November 11, 2015
BOARD OF COUNTY COMMISSIONERS
ORANGE COUNTY, FLORIDA
Y16-713-CC / ADDENDUM #1
JOHN BRIDGES COMMUNITY CENTER BUILDINGS D & F HVAC REPLACEMENT

Orange County John Bridges Community Center Buildings D & F HVAC Replacement

SHEET INFORMATION:	
JOB No. 100045178	Date Issued: OCTOBER 25, 2015
Designed By: LF	Sheet Number:
Checked By: FL	E-102
OC Review: GFH	
Phase:

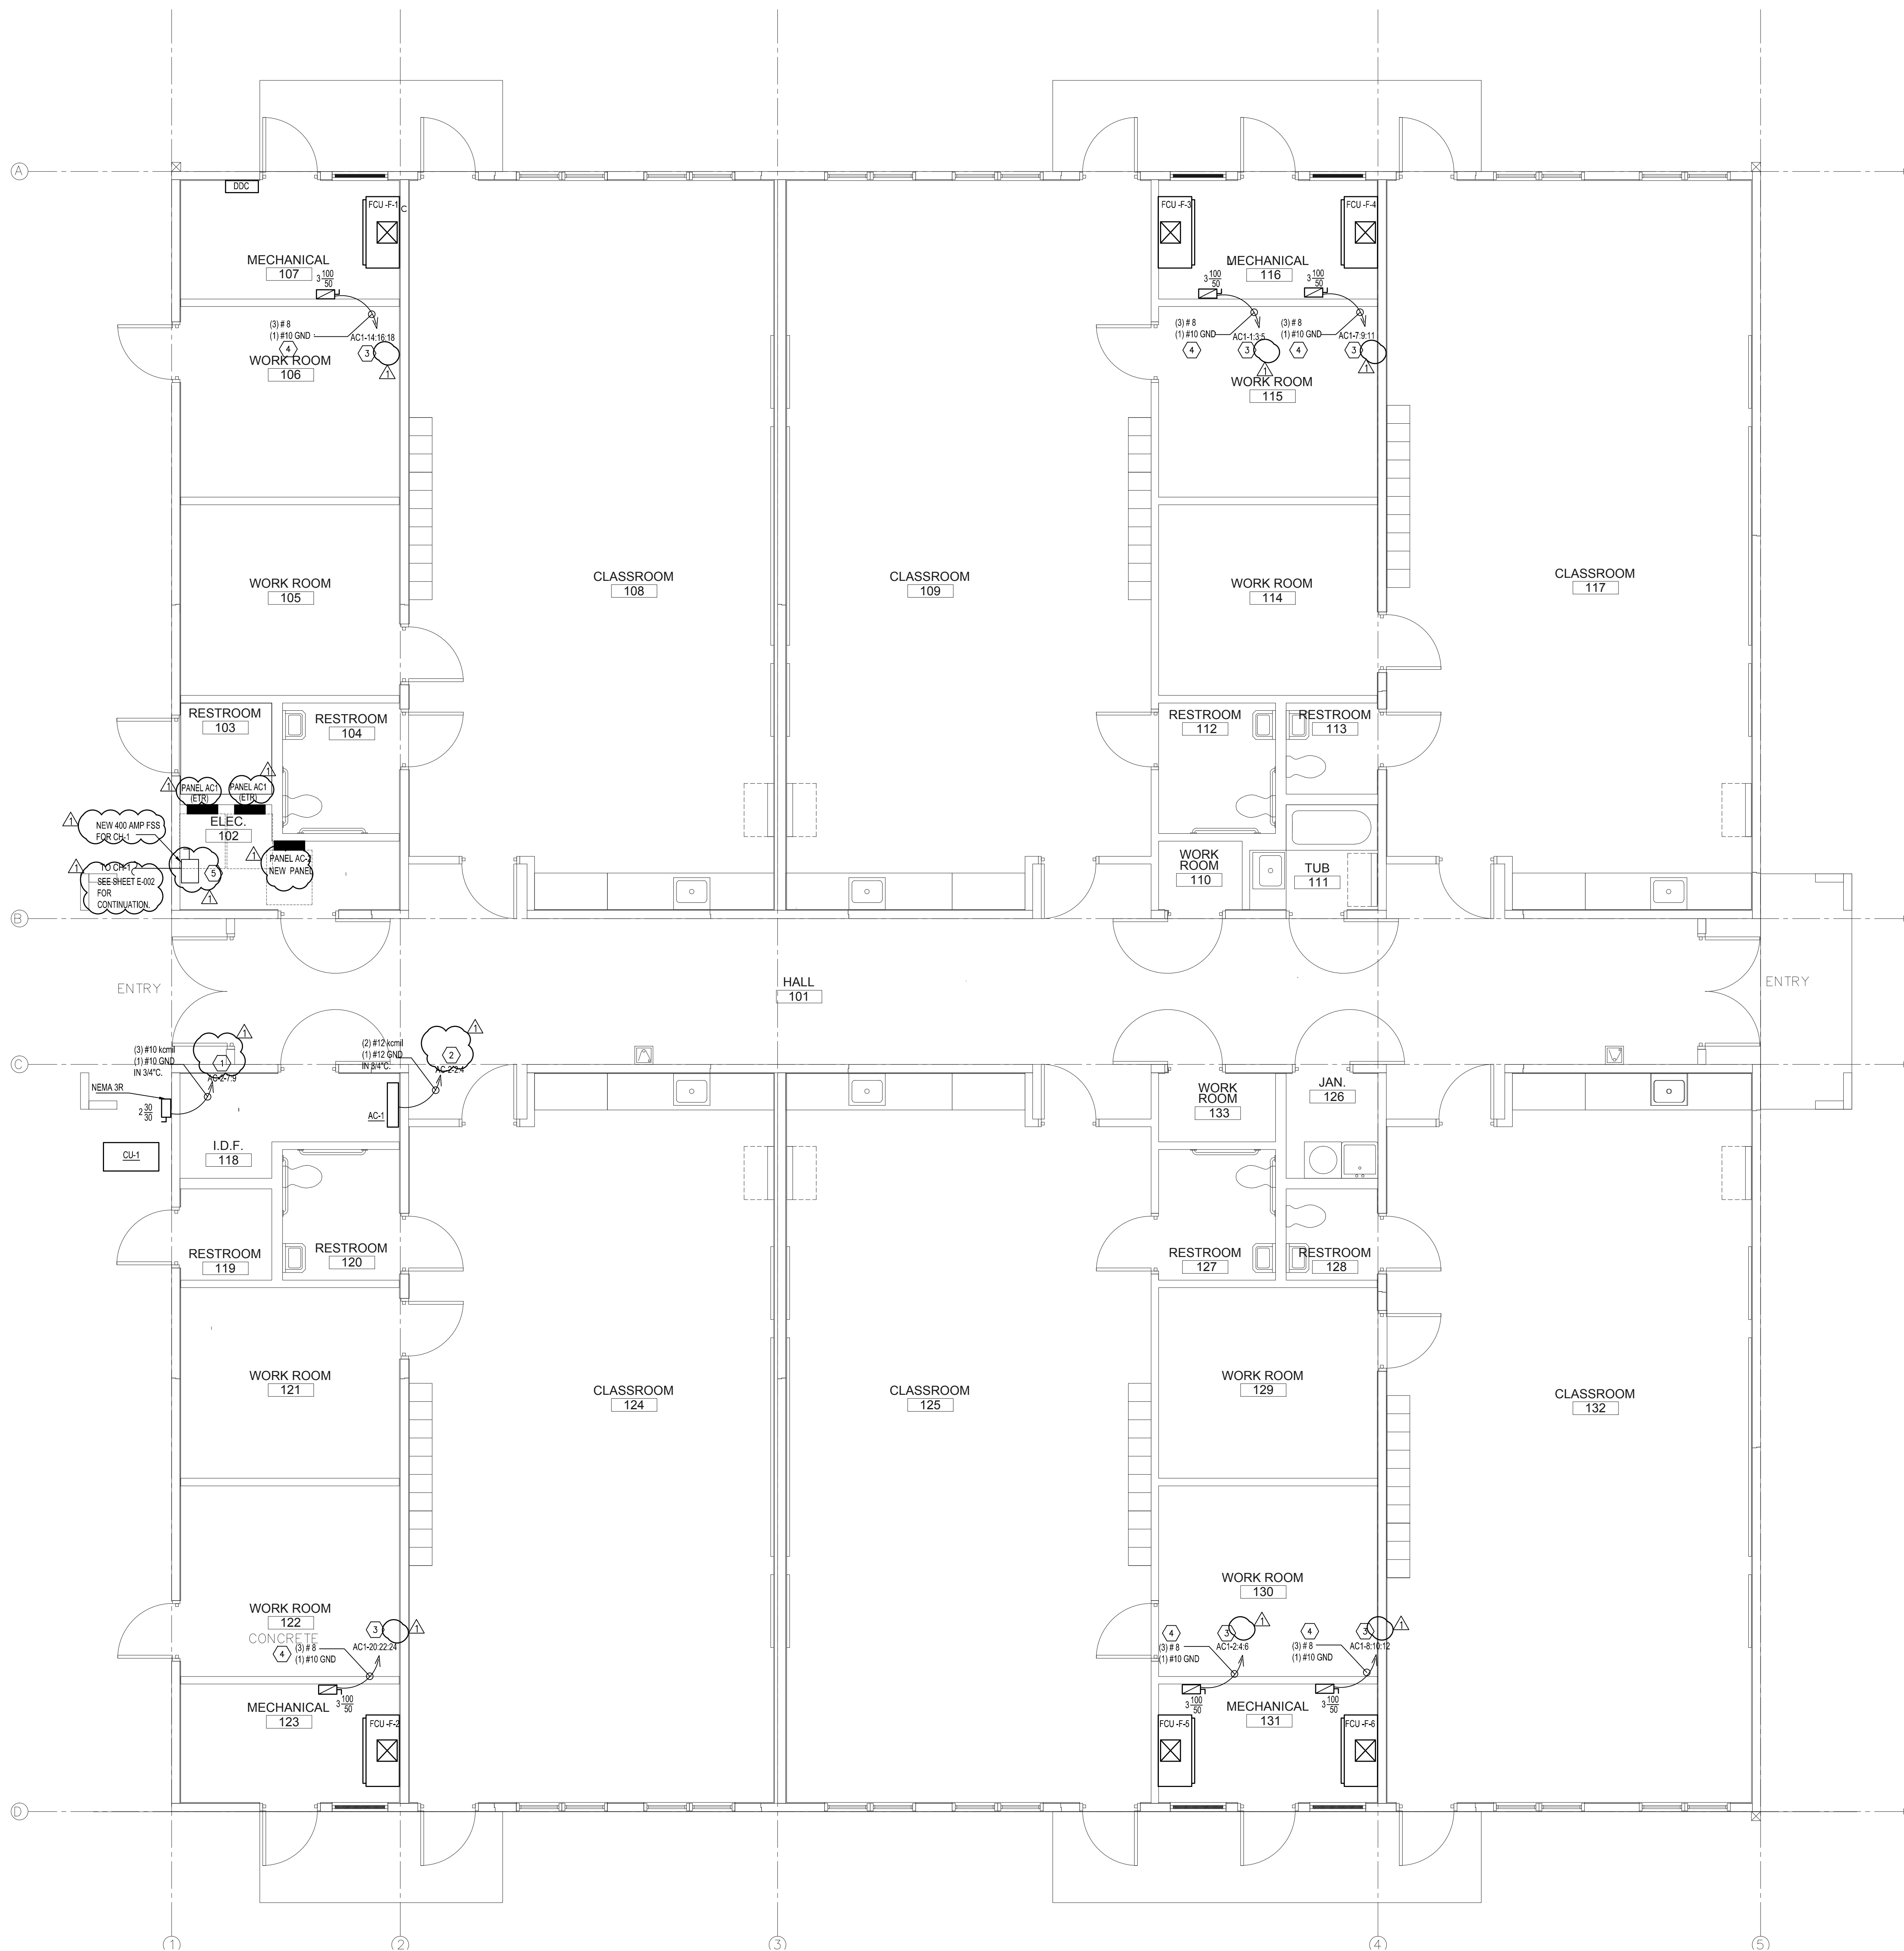
- E-101 -Text font was made consistent,
-clarified Sheet Notes and Keyed Notes,
-revised load summaries for panels KC and KD
- E-102 -Text font was made consistent,
-clarified Sheet Notes and Keyed Notes.
